HISTORIC DISTRICT COMMISSION **NOTICE OF DENIAL**

Notification Date: 10/15/25 Application Number: HDC2025-00593

VIRGINIA PARK TOWNES

Front - South Elevation - Building 1 SCALE: 1/8" = 1'-0" VIRGINIA PARK AVENUE 10-UNIT BUILDING

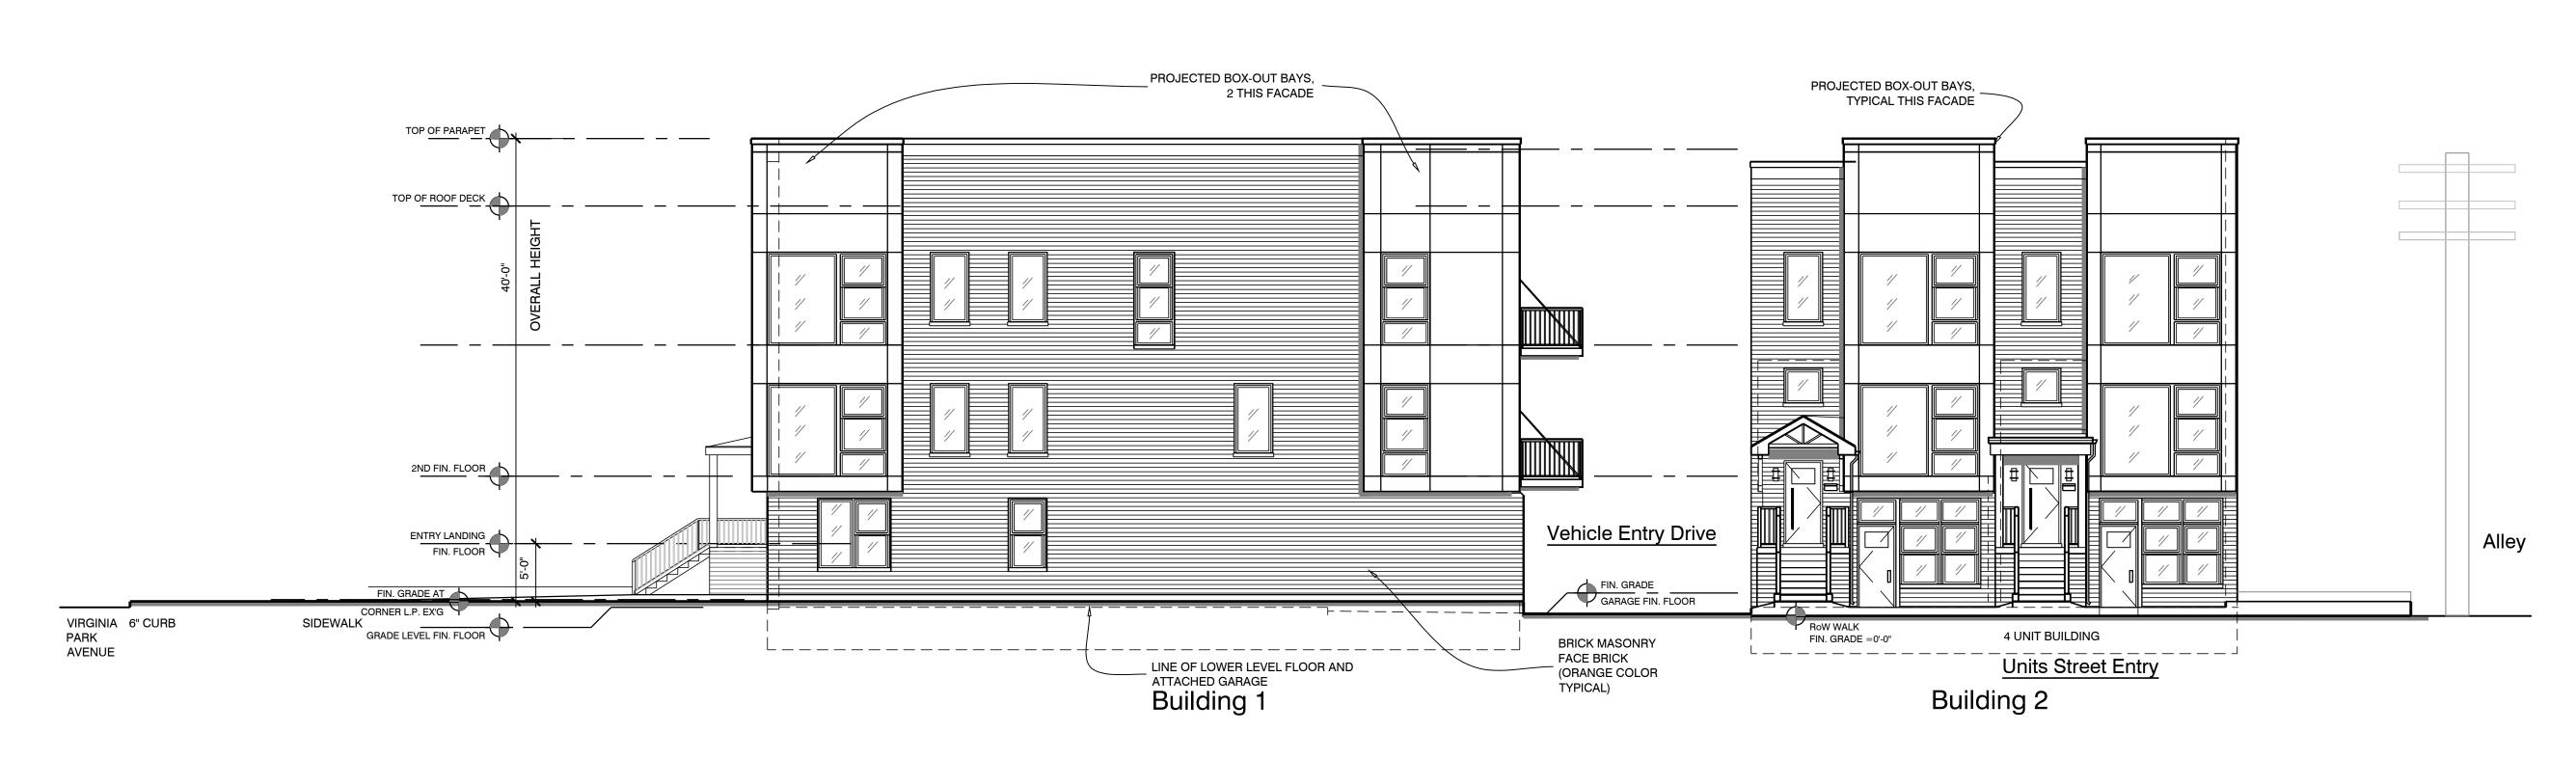
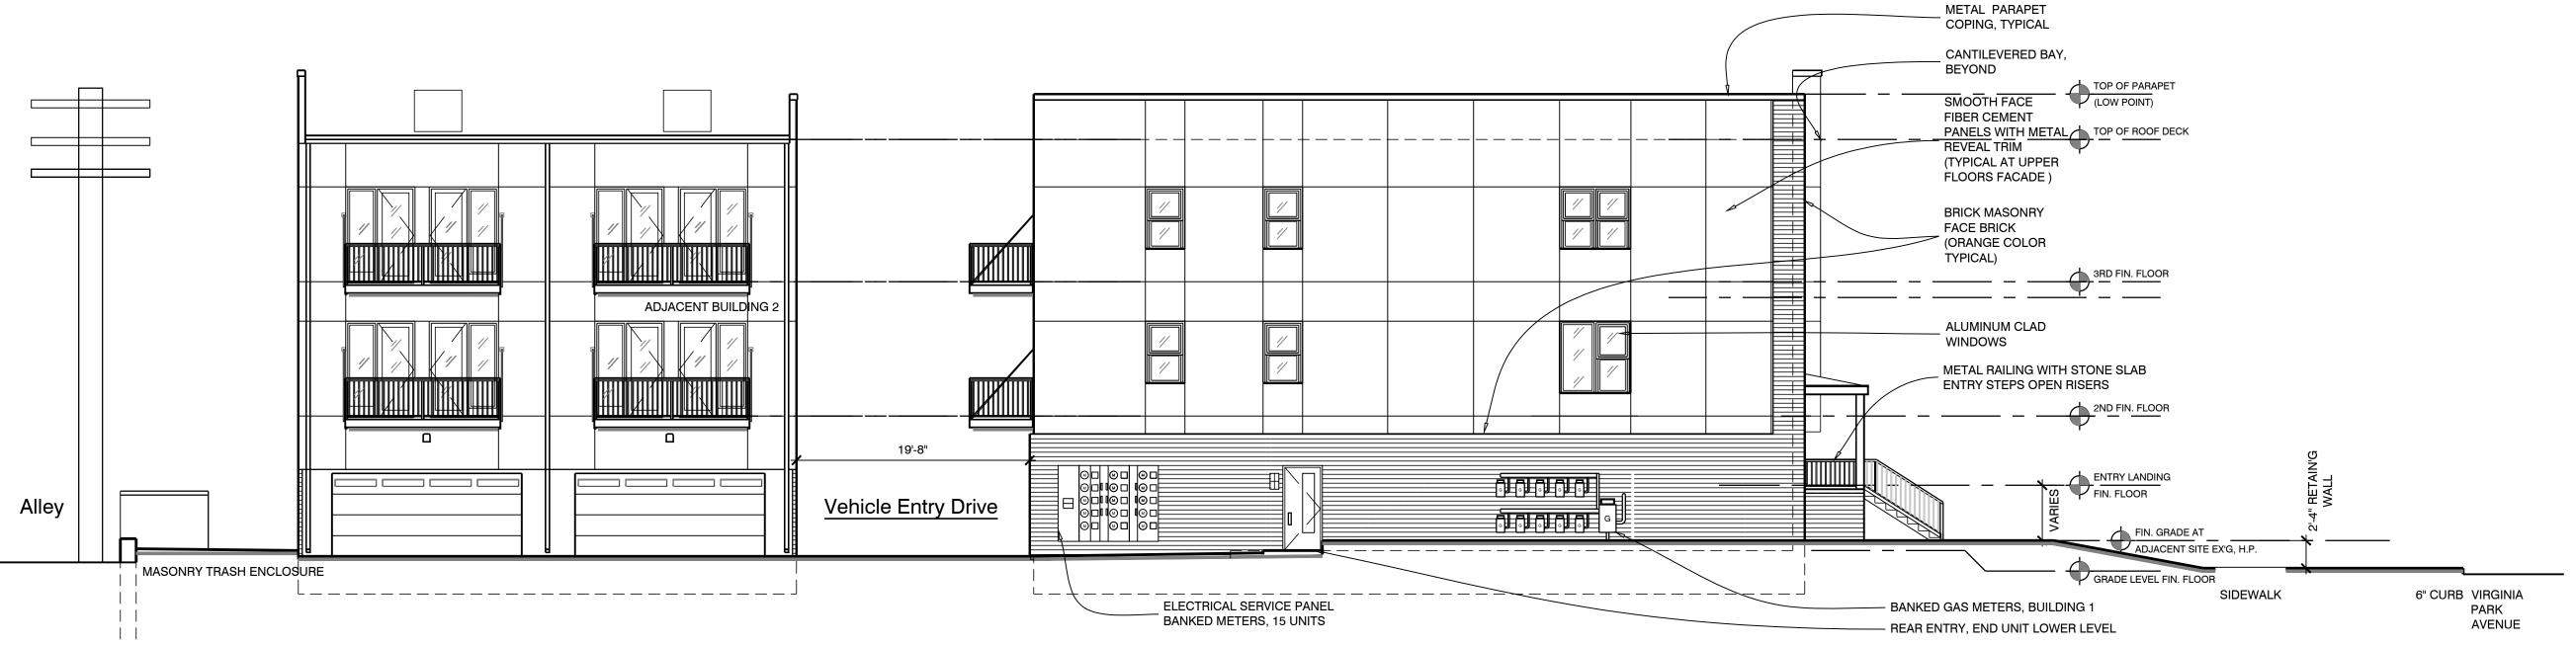
- Based on the historic context on Virginia Park, the proportion of the front façade should appear taller than wide or wider than tall, with an overall neutral appearance. The proposed attached dwellings are substantially wider than tall, very far from neutral.

- Cement panels with metal reveal trim are not reasonably related to a historic material precedent on Virginia Park Avenue. The extensive use of these modern panels on these proposed buildings makes them the default primary expression and substantially at odds with the historic context.

- Despite the addition of some elements at the porches and garden units, the revised proposal does not incorporate "ornate" architectural detailing as specifically called out in the Elements of Design for Virginia Park.

- Flat roofs, despite the addition of more traditional forms at the porches, remain the dominant expression in the revised design and are not compatible with the existing character of Virginia Park, which is universally marked by pitched and complex roof forms of various types.

- The scale of the facades in the proposal are not compatible with the scale/complexity of the facades on the historic buildings along Virginia Park.
- The directional expression of the proposed front elevations is not compatible with the overall "neutral" directional expression of the houses on Virginia Park.

- The degree of complexity in the facades of the existing houses on Virginia Park requires a similar complexity in a historically compatible new structure, independent of the style, which is not achieved by the proposal.
